City of Portland, Maine – Building or Use Permit Application 389 Congress Street, 04101, Tel: (207) 874-8703, FAX: 874-8716

Location of Construction: 118 Hussey Rd, Peaks Isl		Owner: Feeney, John & Lorraine		Phone:		Permit No: 971047 <div style="border: 2px solid black; padding: 5px; text-align: center;"> PERMIT ISSUED SEP 30 1997 CITY OF PORTLAND </div> Permit Issued: Zone: CBL: 085-G-015	
Owner Address: SAA Ptld, ME		Lessee/Buyer's Name:		Phone:			BusinessName:
Contractor Name:		Address:		Phone:			
Past Use: 1-fam		Proposed Use: Same		COST OF WORK: \$ 30,000.00 FIRE DEPT. <input type="checkbox"/> Approved <input type="checkbox"/> Denied Signature:		PERMIT FEE: \$ 170.00 INSPECTION: Use Group: 93 Type: 503 Signature: <i>Hoffman</i>	
Proposed Project Description: Make Interior Renovations				PEDESTRIAN ACTIVITIES DISTRICT (P.A.D.) Action: <input type="checkbox"/> Approved <input type="checkbox"/> Approved with Conditions <input type="checkbox"/> Denied Signature: _____ Date: _____			
Permit Taken By: Mary Gresik		Date Applied For: 24 September 1997

DATE: 26 Sept, 97 ADDRESS: 118 Hussey Rd. P.I.
REASON FOR PERMIT: To make INT. Reno
BUILDING OWNER: Feeney, John & Lorraine
CONTRACTO

REMODELING

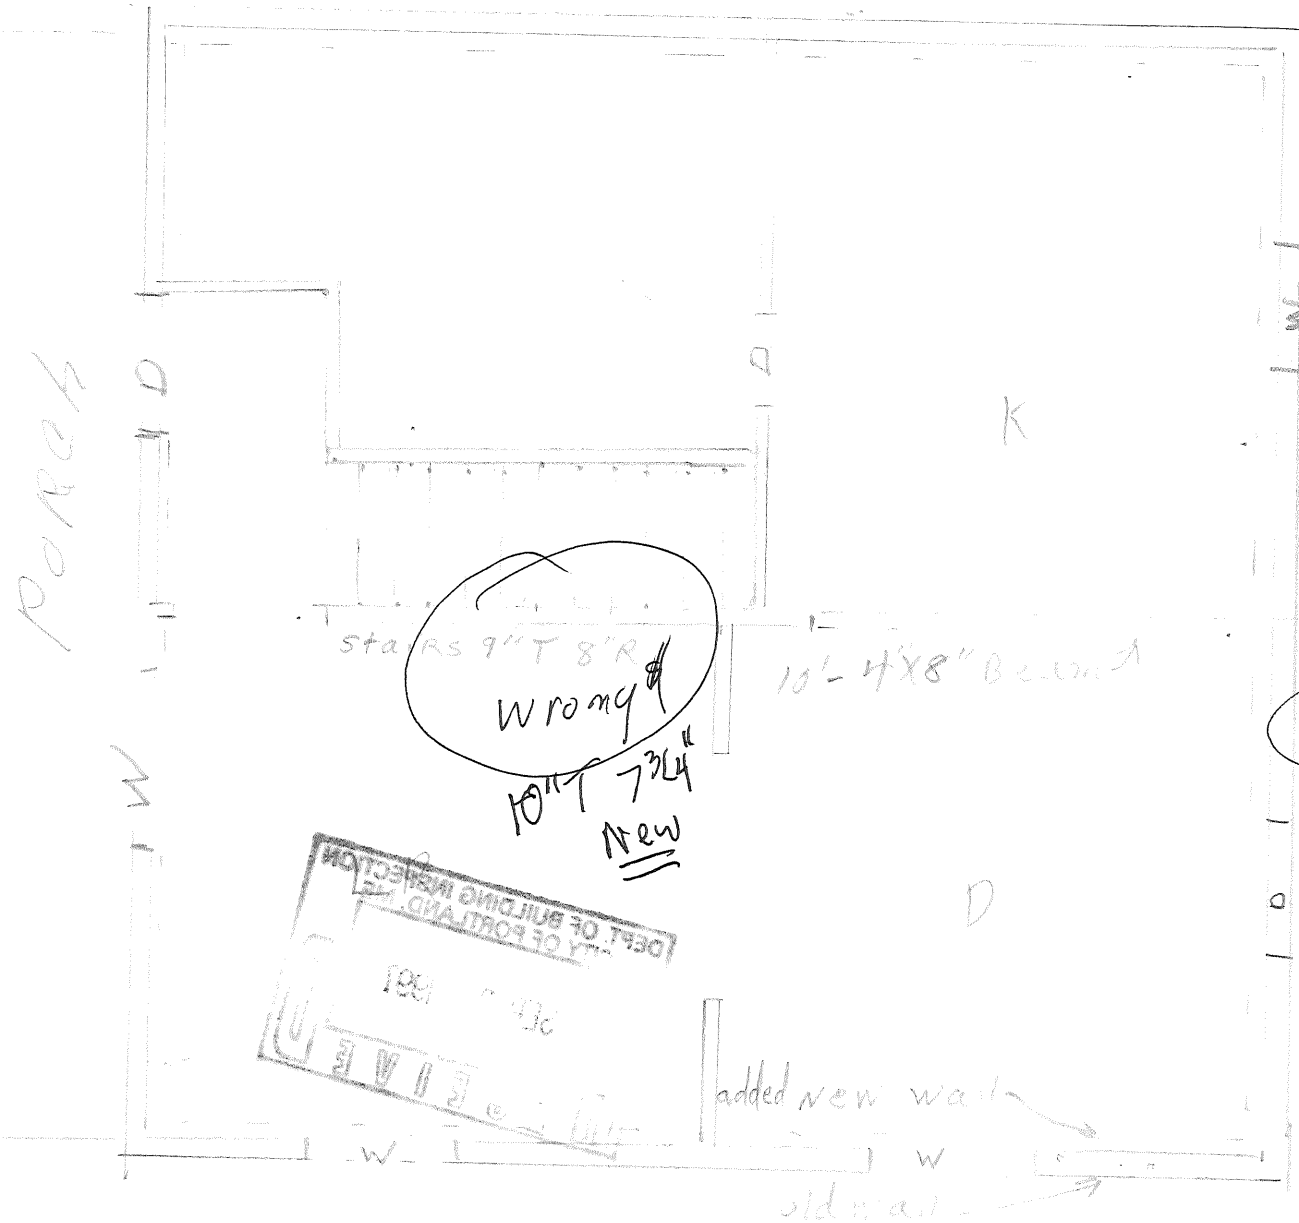
- *9. Headroom in habitable space is a minimum of 7'6".
- *10. Stair construction in Use Group R-3 & R-4 is a minimum of 10" tread and 7 3/4" maximum rise. All other Use group minimum 11" tread, 7" maximum rise.

- *11. The minimum headroom in all parts of a stairway shall not be less than 80 inches.
- *12. Every sleeping room below the fourth story in buildings of use Groups R and I-1 shall have at least one operable window or exterior door approved for emergency egress or rescue. The units must be operable from the inside without the use of special knowledge or separate tools. Where windows are provided as means of egress or rescue they shall have a sill height not more than 44 inches (1118mm) above the floor. All egress or rescue windows from sleeping rooms shall have a minimum net clear opening height dimension of 24 inches (610mm). The minimum net clear opening width dimension shall be 20 inches (508mm), and a minimum net clear opening of 5.7 sq. ft.
